S E R V I C E N O T E

37717B PDH/SDH/Jitter Test Set

Upgrading the Instrument Firmware

Page 2 Service Note 37717B-01

Figure 1 - Location of Disc-drive or Rom Drawer in the 37717B

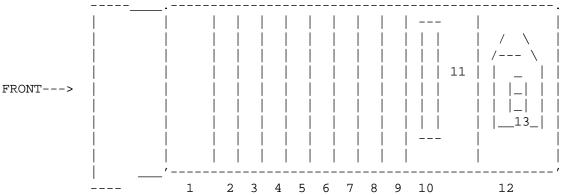
To check if a disc-drive is fitted, look on the right-side of the instrument and compare with Item 11 in Figure 1.

If Item 11 is a metal plate secured with 2 pozidrive screws, upgrade the firmware using the eeproms in Table 1 above. If Item 11 has a slot for a 3.5 inch floppy disc, upgrade the firmware using the set of discs in Table 1 above.

- 1. Switch off the instrument and disconnect the power cord.
- 2. Remove the two screws securing the ROM Drawer Cover to the CPU Module (see Fig 1 below) and carefully extract this drawer out of the module.
- 3. Remove eeproms from their sockets and fit new eeproms as shown in Figure 2.
- 4. Fit the ROM Drawer Assembly with new eeproms back into the instrument, replace the ROM Drawer cover and secure with the two screws.
